**SUBDIVISION, &
ZONING AMENDMENT STAFF REPORT****Date: September 1, 2022****NAME**

Benchmark Homes Group, LLC

Preserve at Milkhouse Creek Subdivision

DETAIL SITE PLAN

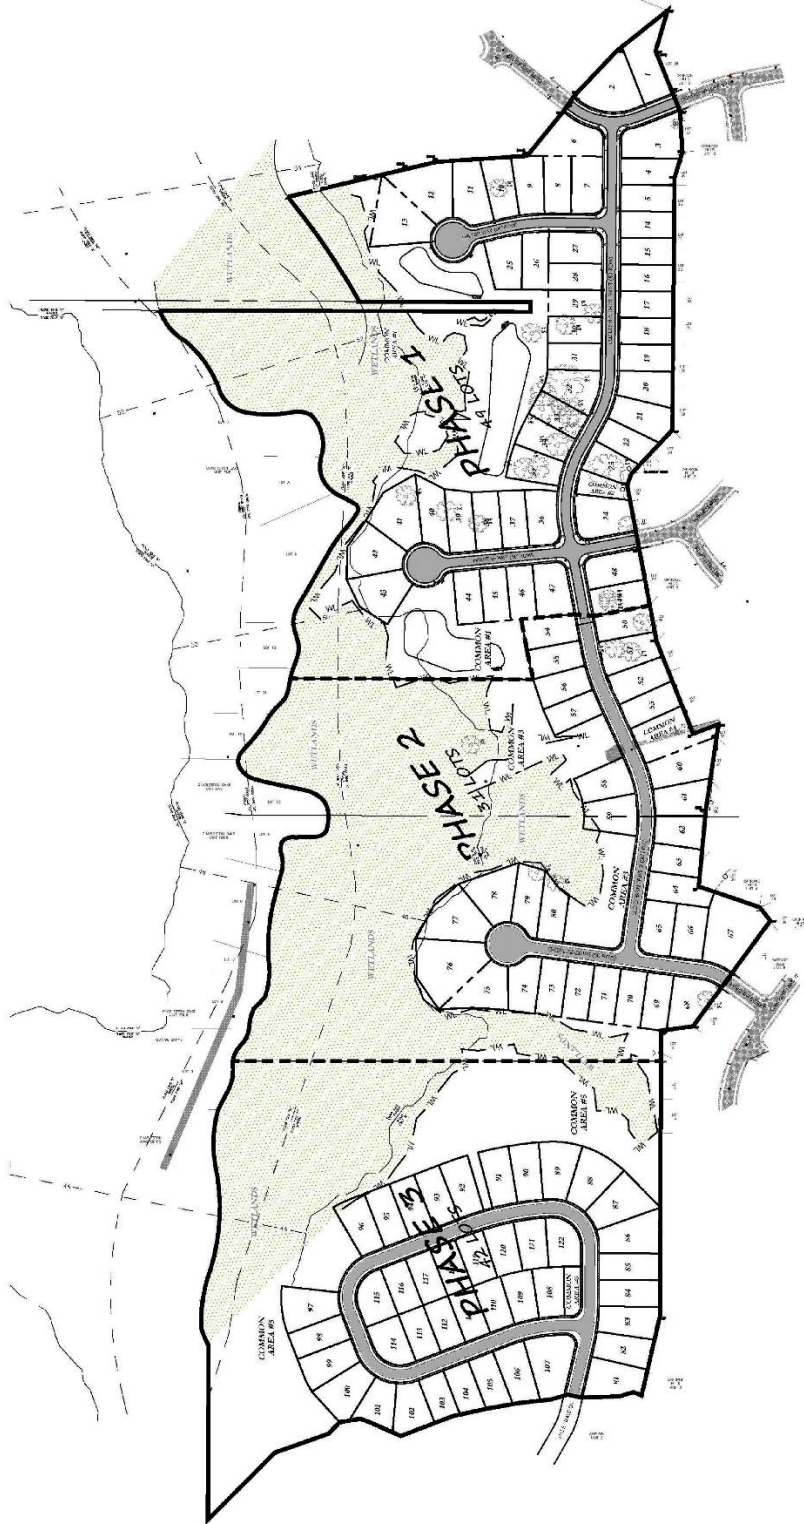
- B. On Sheet 1 of 3 - correct the LOT numbers shown in the DRAWING INDEX.
- C. On Sheet 1 of 3 - show and label the existing ROW for Blue Ridge Blvd., Old Dobbin Dr. N., Old Dobbin Dr. W., and Harness Way.

SHEET 2 OF 3

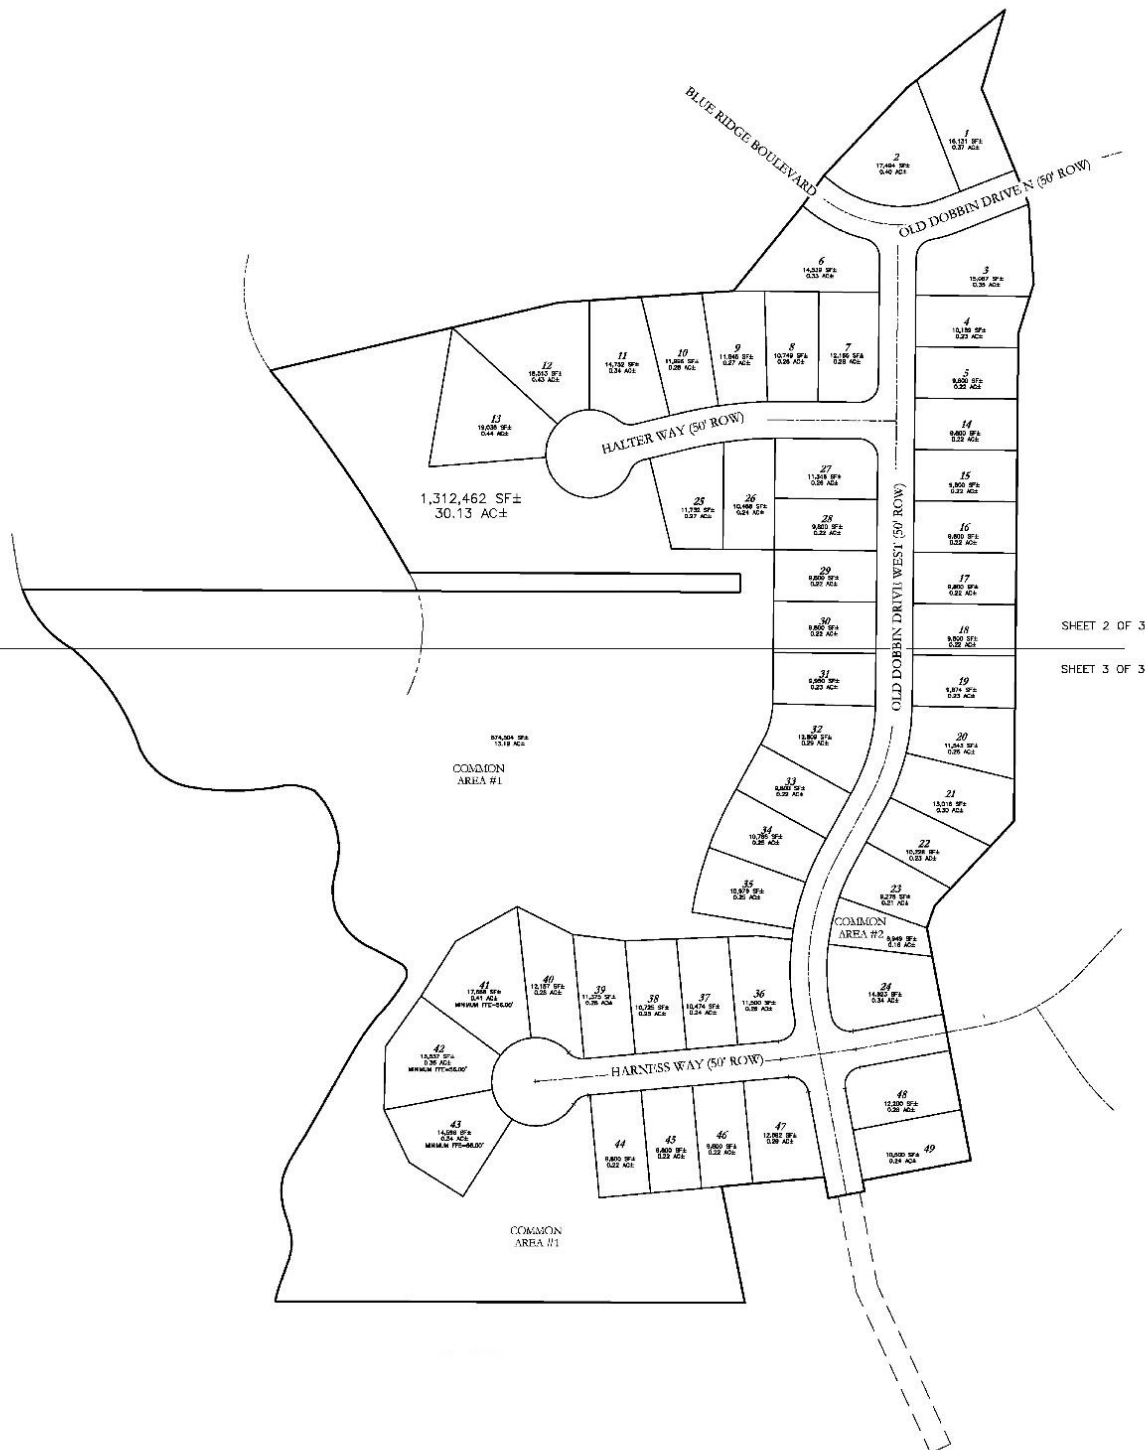
- D. Sheet 2 of 3 - show and label the existing ROW for Blue Ridge Blvd. Old Dobbin Dr. N., and Wagon Tongue Dr.
- E. Sheet 2 of 3 – Provide the exact measurement “observed” on the property lines that begin/end in Milhouse Creek. The monumentation indicates that an exact measurement should be available.

- F. Sheet 2 of 3 – Label each and every Common Area.
- G. Sheet 3 of 3 – show and label the existing ROW for Old Dobbin Dr. W., and Harness Way.
- H. Sheet 3 of 3 – Show and label the BFE (Base Flood Elevation) on each lot (LOT 41, 42, & 43) that contains an AE, V, or X (shaded) flood zone designation. BFE for that portion is elevation 51’.

- I. Sheet 2 & 3 - Check and revise the distances shown on the Plat and in the legal description. Four (4) legs do not show the bearing, and one (1) does not show the distance.

- J. Sheet 2 & 3 - Check the monumentation and written bearing and distance for the part that includes the western property line along Milkhouse Creek. The distances shown and written should be exact distances since the distance is between sets of capped rods.
